# Access Compliance Report

## Public Rights-of-Way

### (Curb Ramps)

Intersection ID: 29425	Main Street: BRADSTREET_COMMONS_WY	Cross Street: NOVELLA_DR	Location: N
ADA ID: AFEDE7380ADA	Ramp Type: Perp	Initial Pass/Fail: Fail	Overall Compliance: No
Codes/Mitigation Info/Possible Solution		Field Measurements/Component Compliance	
Severity Score: 46.25

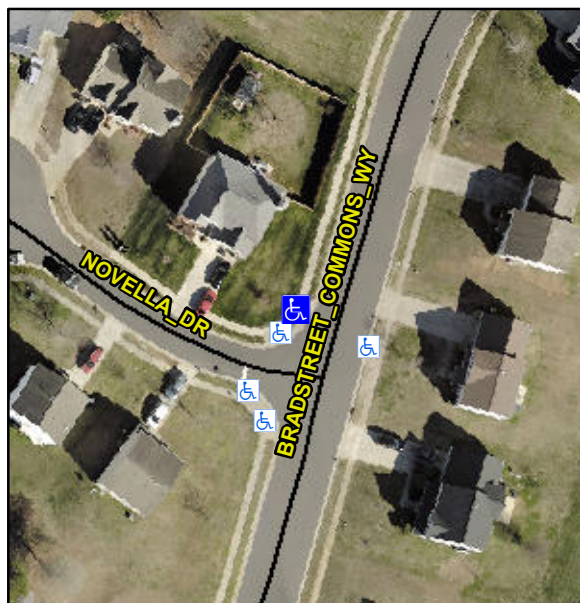
**Not Found, R304.5.1, R304.2.2, R304.5.3**

Compliance	Description	Data	Compliance	Description	Data
N/A	Ramp Length (in)	47.5	No	Ramp Slope (%)	11.6
No	Ramp Width (in)	47.0	No	Ramp XSlope (%)	12.9
N/A	Flare Type LT	N/A	N/A	Flare Type RT	N/A
N/A	Flare Slope LT (%)	N/A	N/A	Flare Slope RT (%)	N/A
N/A	Flare Traversable LT?	N/A	N/A	Flare Traversable RT?	N/A
N/A	Landing Length (in)	N/A	N/A	DWS Provided?	N/A
N/A	Landing Width (in)	N/A	N/A	DWS Contrast?	N/A
N/A	Landing Slope (%)	N/A	N/A	DWS Length (in)	N/A
N/A	Landing X Slope (%)	N/A	N/A	DWS Full Width?	N/A
N/A	Landing Curb? (Y/N)	N/A	N/A	DWS Offset (in)	N/A
N/A	Shared Landing?	N/A			
N/A	Gutter Ponding?	N/A	N/A	Gutter Slope (%)	N/A
N/A	Gutter Lip Ht (in)	N/A	N/A	Gutter X Slope (%)	N/A
N/A	Painted X Walk1?	No	N/A	Painted X Walk2?	N/A
	X Walk 1 Direction	To SE		X Walk 2 Direction	N/A
N/A	X Walk 1 Width (in)	N/A	N/A	X Walk 2 Width (in)	N/A
	X Walk 1 Slope (%)	4.2		X Walk 2 Slope (%)	N/A
	X Walk 1 X Slope (%)	6.7		X Walk 2 X Slope (%)	N/A

**Remove & Replace Entire Ramp.**
